Barbara J. Schussman
BSchussman@perkinscoie.com
D. +1.415.344.7168
F. +1.415.344.7368**VIA EMAIL**BDCP/WaterFix Comments
P.O. Box 1919, Sacramento, CA 95812
BDCPComments@icfi.com**Re: Partially Recirculated Draft Environmental Impact Report /
Supplemental Draft Environmental Impact Statement
(RDEIR/SDEIS) for the Bay Delta Conservation Plan/WaterFix**

Bay Delta Conservation Plan / California WaterFix
Partially Recirculated Draft Environmental Impact Report /
Supplemental Draft Environmental Impact Statement

Contra Costa Water District
Comments on the July 2015 RDEIR/SDEIS for the
Proposed Bay Delta Conservation Plan / California WaterFix

Figure 3-1. Regional map of the South Delta

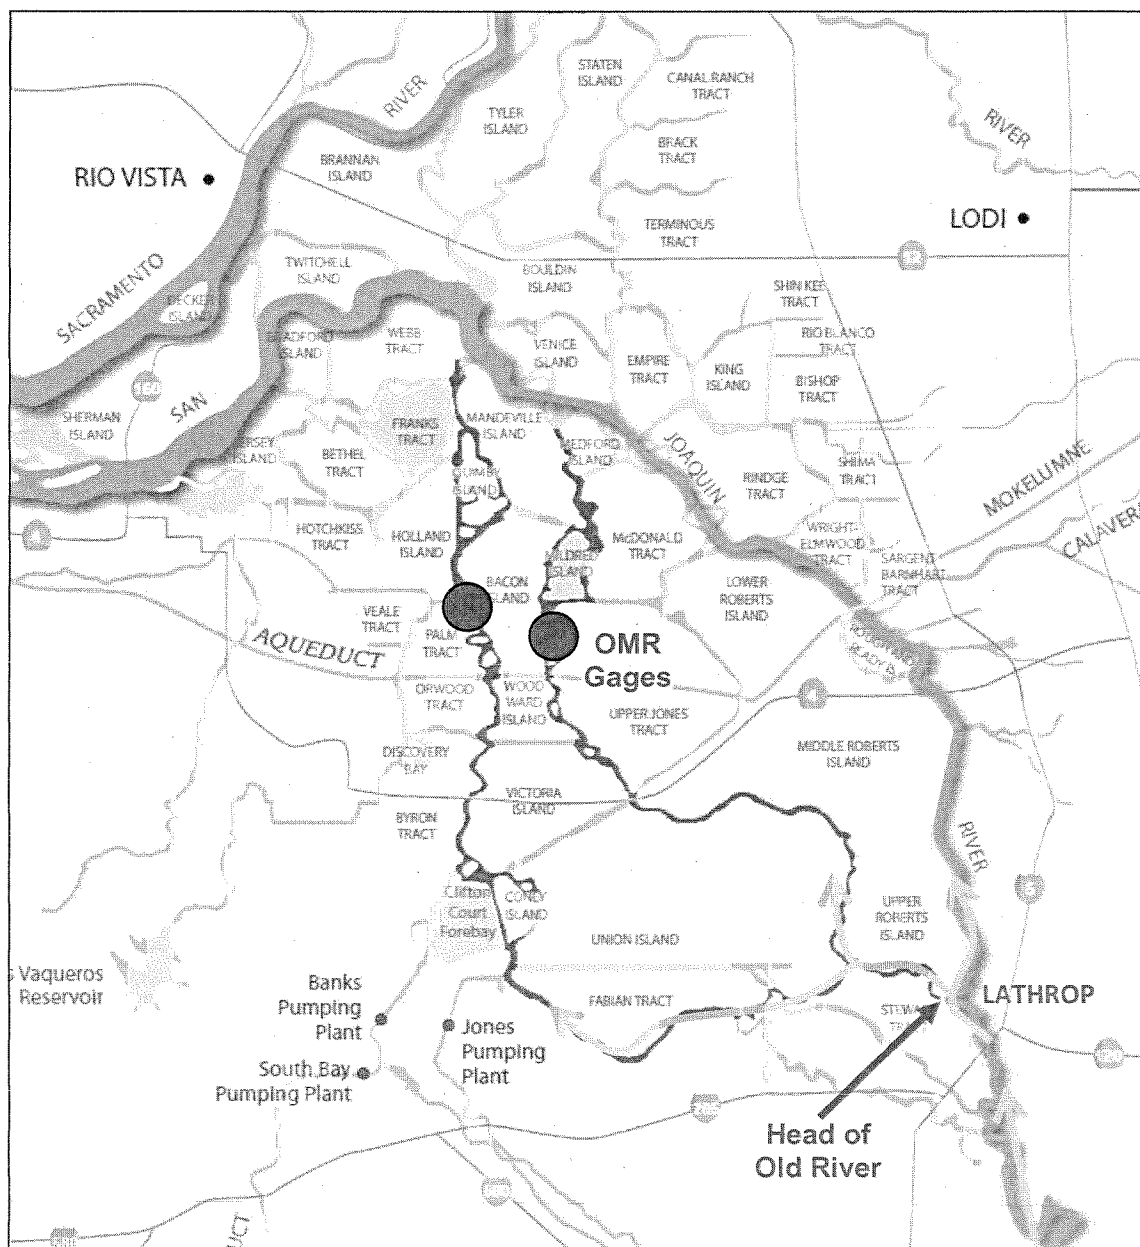
The description of the revised Alternative 4 and new Alternative 4A includes requirements for positive net flows in Old and Middle Rivers at times when the Head of Old River Barrier (HORB) is closed, although positive net flows are not physically possible when the barrier is closed. The hydrodynamic and water quality modeling, which is based upon numerical formulations of real-world physical processes, thus cannot match the unrealistic project description. As discussed in Section 5.3 below, this inconsistency results in an inadequate and inconsistent project description and an insufficient evaluation of the project’s water quality impacts.

Old River and Middle River are natural distributaries of the San Joaquin River. Figure 3-1 shows the head of Old River where Old River branches off from the San Joaquin River near Lathrop in the South Delta. Downstream of the head of Old River, Middle River branches off from Old River. Water entering the Delta via the San Joaquin River (orange arrows on Figure 3-1) would naturally split at the head of Old River junction, feeding a northerly flow into Old and Middle Rivers; this is the only source of northerly net flow in Old and Middle Rivers (OMR). Net southerly flow in Old and Middle Rivers is caused by water diversions at intakes located south of the flow gages on Old and Middle Rivers. The CVP and SWP pumping plants in the south Delta (Jones and Banks, respectively) are the dominant cause of net southerly flow. Northerly net flow is positive OMR, while southerly net flow is negative OMR.

Figure 3-2. Old and Middle River flow when HORB is closed

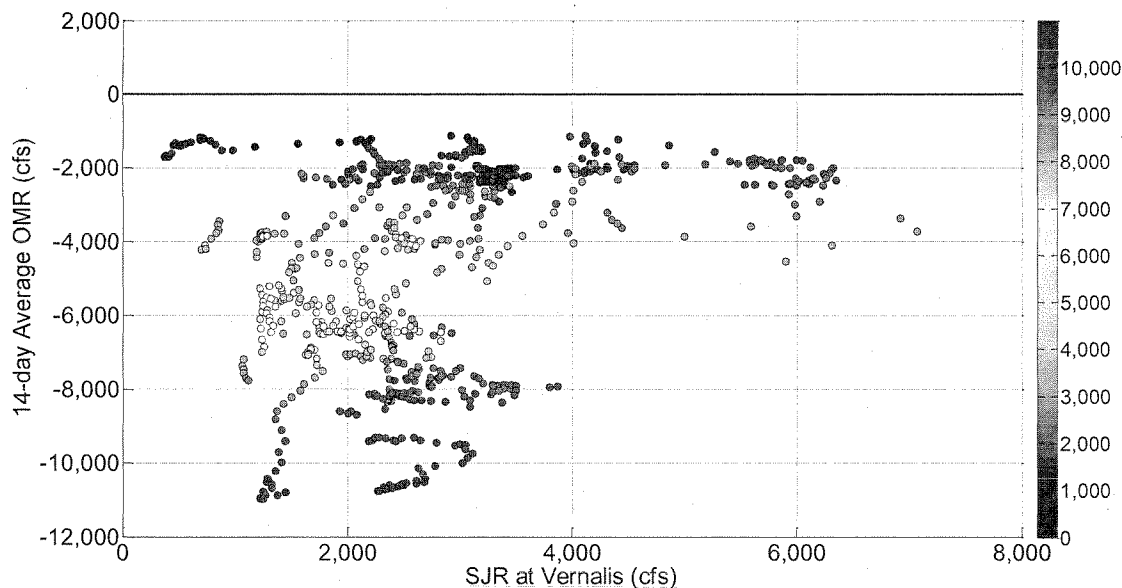
Closure of the HORB blocks flow in the San Joaquin River from entering Old River which, as discussed above, is the only source of positive OMR; closure of the HORB thus prevents OMR from being positive. As a result, the project description for OMR flow requirements is internally inconsistent with the project description for HORB operation in two-thirds of the analysis period.

This inconsistency is demonstrated by reviewing measurements of OMR flows at times when a barrier has been installed at the head of Old River in the past. Historically, a temporary barrier of rocks at the head of Old River has been constructed in the fall or spring¹. Review of OMR flows that were measured when the HORB was installed confirms that OMR is never positive with the HORB installed (Figure 3-2).

Pumping at the existing CVP and SWP export facilities in the south Delta (Jones and Banks, respectively) contributes to negative OMR – the greater the total pumping at the existing south Delta facilities, the more negative OMR (Figure 3-2). Limiting pumping at the south Delta facilities limits the negative OMR but cannot create positive OMR. Positive OMR can only occur with inflow from the San Joaquin River when the HORB is *not* installed.

Figure 3-3. Frequency of Excess Outflow in October

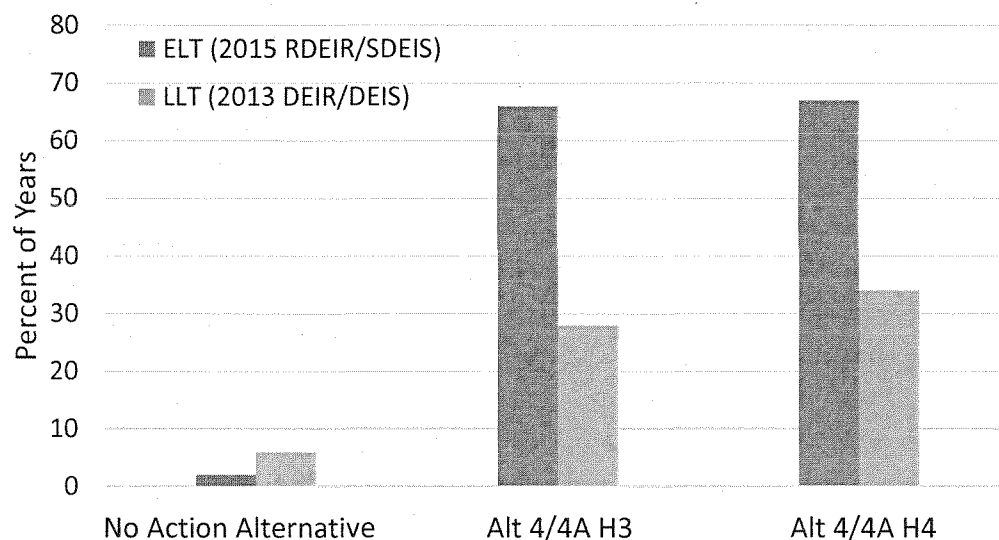
However, the BDCP modeling indicates that Delta outflow would exceed the amount necessary to meet minimum outflow requirements and salinity standards over 66% of the time in the early long term (ELT) for Alternatives 4/4A² H3 and H4 (Figure 3-3). In comparison, the No Action Alternative³ has excess Delta outflow in October only 2% of the time in the ELT.

The dramatic increase in the occurrence of excess flow under Alternatives 4/4A H3 and H4 in the ELT is not as substantial in the late long term (LLT) and is probably the cause for the different impact determinations between the ELT (as analyzed in the RDEIR/SDEIS) and the LLT (as analyzed in the 2013 BDCP Draft EIR/EIS). Although excess October Delta outflow occurs less often in the Alternative 4/4A LLT modeling than in the Alternative 4/4A ELT modeling, the frequency of occurrence in the LLT modeling is also unrealistic.

Figure 3-4. Closure of the Delta Cross Channel maintains higher flow in the Sacramento River

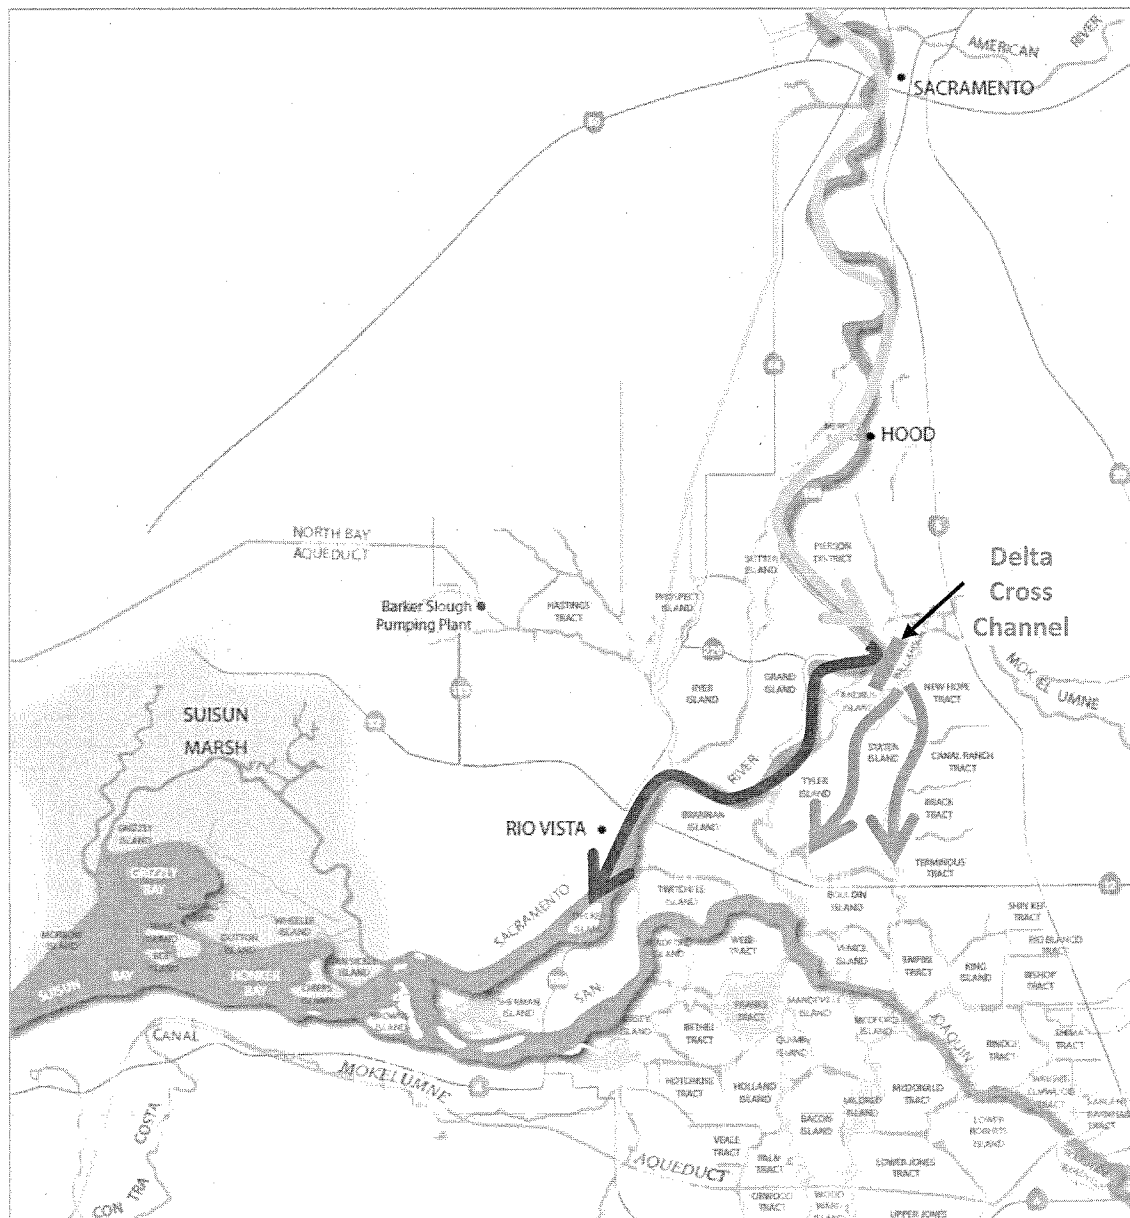
When the Delta Cross Channel gates are open, a portion of the Sacramento River flow enters the central Delta, reducing flow in the Sacramento River downstream of the Delta Cross Channel (Figure 3-4). To meet flow requirements in the Sacramento River at Rio Vista, DWR and Reclamation have two options: (1) increase reservoir releases to increase the Sacramento River flow entering the Delta, or (2) close the Delta Cross Channel gates to increase the amount of flow that reaches Rio Vista without increasing Sacramento River inflow.

The operational strategy to close the Delta Cross Channel to meet Rio Vista flows without unnecessary reservoir releases has been implemented recently in November of 2009 and in October of 2013 and 2014 (Reclamation, 2015). This is the realistic operational strategy that should have been used in the modeling. Failure to model this operational strategy, when it has in fact been implemented repeatedly in recent years, biases the salinity results in the water quality impacts analysis, showing reduced salinity with the project. In reality, when the Rio Vista flow requirements are met by closing the Delta Cross Channel instead of by releasing flow from upstream reservoirs, interior Delta salinity will increase with the project.

Figure 3-5. Excess Delta Outflow in the month of October during the Early Long Term biases the modeling results for multiple months

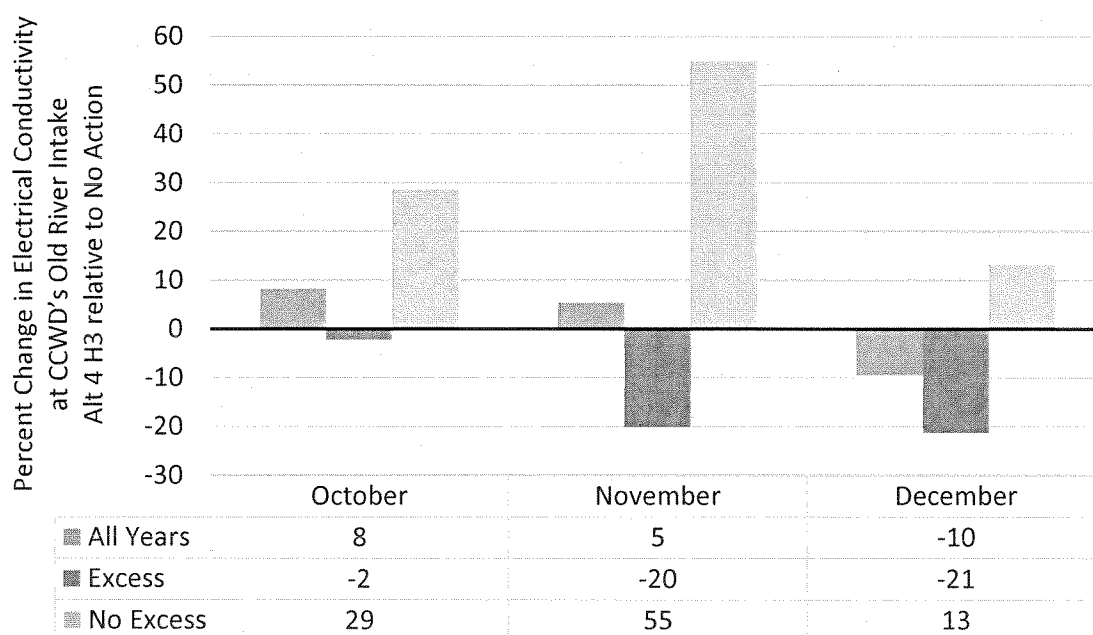
The unrealistic excess Delta outflow in October freshens the modeled interior Delta salinity for many months. This is illustrated in Figure 3-5, which shows that excess Delta outflow in October freshens the water at CCWD's Old River Intake in October and that the freshening effect is maintained through December (blue bars in Figure 3-5). In contrast, during years without excess Delta outflow in October, Alternative 4/4A H3 increases the salinity at CCWD's Old River Intake in October, November, and December (orange bars in Figure 3-5). Further, averaging salinity over all years (green bars in Figure 3-5) underestimates the impacts that would occur.

This discussion serves to show that the unrealistic assumption of excess Delta outflow results in a significant underestimation of salinity impacts as a result of the proposed project. Conversely, implementing and modeling an operations plan that corrects this unrealistic excess Delta outflow assumption would reveal greater salinity impacts due to the project.

Figure 5-1. Change in Salinity due to the ELT Tidal Marsh

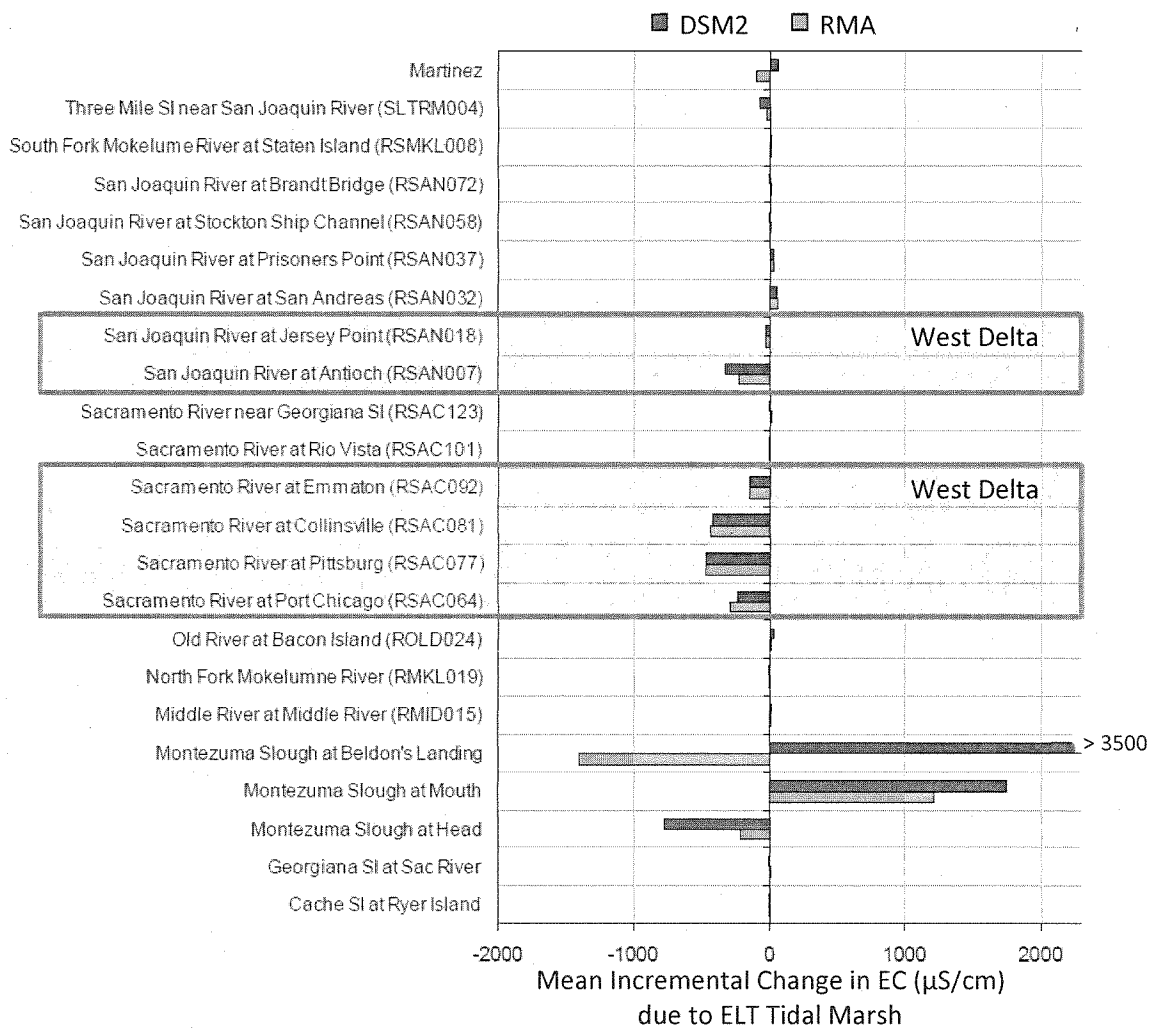
However, there is no evidence presented in the RDEIR/SDEIS to support this conclusion. To the contrary, the analysis in the 2013 BDCP Draft EIR/EIS clearly indicates that the particular configuration of tidal marsh included in the modeling *underestimates* salinity impacts, since the modeled restoration reduces salinity in the western Delta. For example, Figure 5-1 below is a reproduction of a figure from the 2013 BDCP Draft EIR/EIS that shows the incremental change in electrical conductivity (EC) due to the ELT tidal marsh configuration (25,000 acres) that was assumed in the models; the locations in the west Delta are boxed for easy identification. At every location analyzed in the west Delta, the mean incremental change in EC due to the ELT tidal marsh is negative, indicating that the incorporation of the ELT tidal marsh reduces salinity at these locations for both models that are used to simulate salinity in the Delta (i.e., DSM2 and RMA). Multiple figures in the 2013 BDCP Draft EIR/EIS illustrate that the ELT tidal marsh configuration reduces salinity in the west Delta. *See, e.g.*, 2013 BDCP Draft EIR/EIS, Appendix 5A, Section D, Attachment 2, Figures 6-26, 6-29, 6-32, 6-35, and 6-41 and Attachment 4, Figures 1-69 to 1-72.

In short, the tidal marsh assumed for the ELT reduces salinity in the west Delta. Thus, including the ELT tidal marsh in the modeling to simulate the project alternatives, when in fact the tidal marsh will not be constructed as part of the alternatives, *underestimates* the impacts to salinity in the west Delta that would be caused by the alternatives.

Figure 5-2. Monthly Average Salinity at Collinsville both with and without operation of the SMSCG

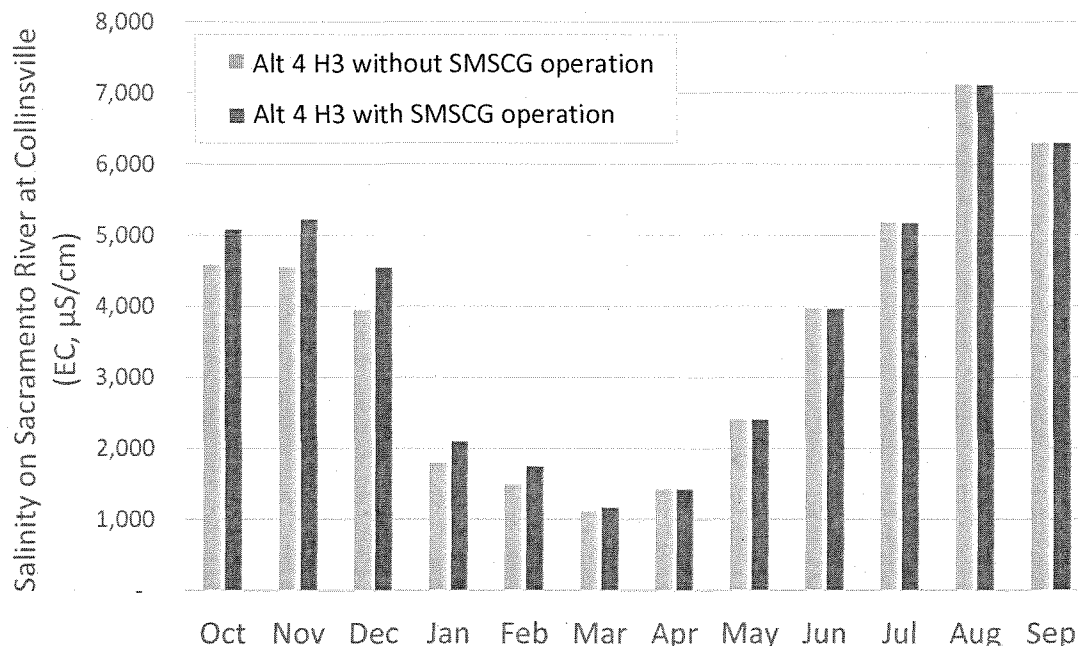
Operation of the gates creates a net flow of fresh water from the Sacramento River near Collinsville into Suisun Marsh equivalent to about 2,800 cubic feet per second (cfs), thus reducing salinity within Suisun Marsh (Enright, 2008, slide 40). The RDEIR/SDEIS contains graphs showing the reduction in salinity within Suisun Marsh in response to operation of the gates. RDEIR/SDEIS, Appendix A, Appendix 8H, Attachment 1 at p. 10 (Figures 9 and 4).

However, diversions of the freshwater into Suisun Marsh via operation of SMSCG *increase* salinity in Suisun Bay and the western Delta (Enright, 2008, slides 43 and 44). The RDEIR/SDEIS does not disclose the degradation in water quality that SMSCG operation would have within Suisun Bay or the Delta. Figure 5-2 below shows changes in salinity in the western Delta at Collinsville that are caused by SMSCG operations. The increase in salinity from October through March is an effect of project operations that is not captured by the outdated modeling that was used to evaluate water quality impacts.

Figure 5-3. HORB affects water quality in the south and central Delta

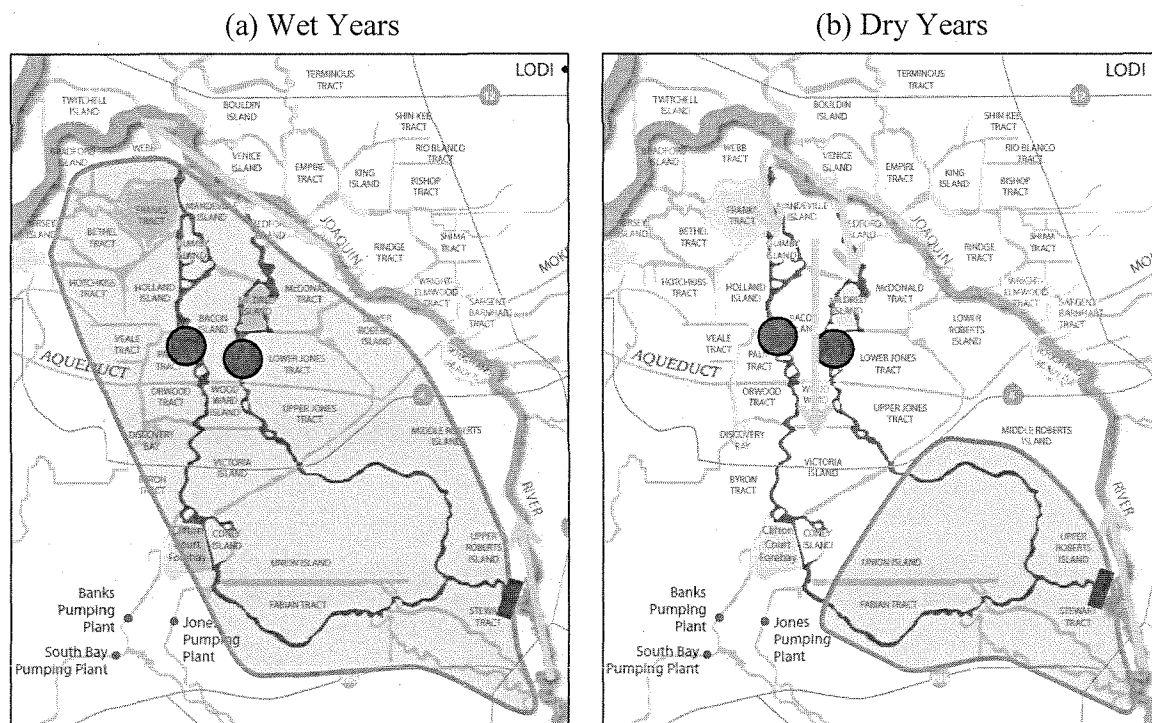
Closure of the HORB impacts the water quality in the south and central Delta; Figure 5-3 shows the geographical extent of the impacts in wet and dry years.

During dry years, the project as described in the RDEIR/SDEIS allows OMR to be negative while the HORB is closed. With no flow entering Old River from the San Joaquin River at the HORB, and with the export pumps operating, the San Joaquin River would flow north past the HORB, then turn south entering Old and Middle Rivers from the north and creating negative OMR (Figure 5-3(b)). The central Delta would receive this water heading from the north, and thus would receive a greater proportion of San Joaquin River water as compared to baseline conditions. This is an important consideration for water quality in the central Delta, since during dry years, San Joaquin River flows are generally low and the water quality is poor. Further, with the HORB closed, stagnant conditions would be created in the south Delta.

For both wet and dry years, impacts would be greater than what is modeled. In the stagnant regions, flow in the channels would oscillate with the tides, but without net flow, the residence time would be very long. (Residence time is estimated by the volume of water in a region divided by the net flow through the region, so as the net flow approaches zero, the residence time approaches infinity.) Long residence times provide optimal conditions for harmful algal blooms as discussed in Section 2.2.1.2 of CCWD's July 25, 2014 comment letter on the 2013 BDCP Draft EIR/EIS.
